# Lawrence Outdoor Pool Renovation Project

# Analysis of Omissions and Errors in Information Presented to the City Commission and the Public

# Request for Citizen Oversight and Advocacy Committee

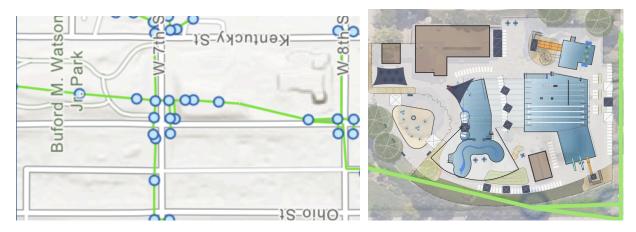
The first picture below is of the relevant section of the stormwater system. The second picture overlays this stormwater information on the preferred design concept to show how the stormwater piping sits just to the west of the current shallow pool. This picture also indicates how the lazy river in the preferred design would have been positioned in the same location that houses the pool's shallow end that's currently sinking.

Nick Hoyt, the City Engineering Project Manager for the Jayhawk Watershed Project, says that this portion of our City's stormwater piping was built within a natural creekbed that runs to the river and that there were "conversations between MSO and Parks & Rec about how the storm tunnel and/or the soils may be contributing to the failures of the zero-depth area." <sup>12</sup>

Mr. Hoyt shared geotechnical data obtained for the stormwater project with the pool design team, but suspects the City did not have this specificity of geotechnical data when they built the shallow end in its current location in 1995 and. He says that "additional geotechnical investigation and analysis is needed specific to the pool project" and that this would be "completed within the pool design."<sup>13</sup>

This geotechnical investigation may indicate that the soils are contributing to the current failure of the shallow end. I am concerned that if the pool renovation design is finalized before obtaining this geotechnical data and it maintains the current shallow pool location, the design could set the shallow end up to fail again in the future or could require greater costs to stabilize the soil.

Mr. Hoyt believes that if the soil conditions under the current shallow end are affecting its structural integrity, potential options would "include removing/replacing the existing poor soils, install[ing] additional foundation or moving the pool features where the geotechnical situation is not an issue." <sup>14</sup>

Our petition requested that the shallow end be separated from the main pool, which the preferred design would have also done. We believe that these concerns about potential soil stability under the current shallow end further supports our request to separate the shallow end, which could be re-located over more stable soils farther north and east of its current location.
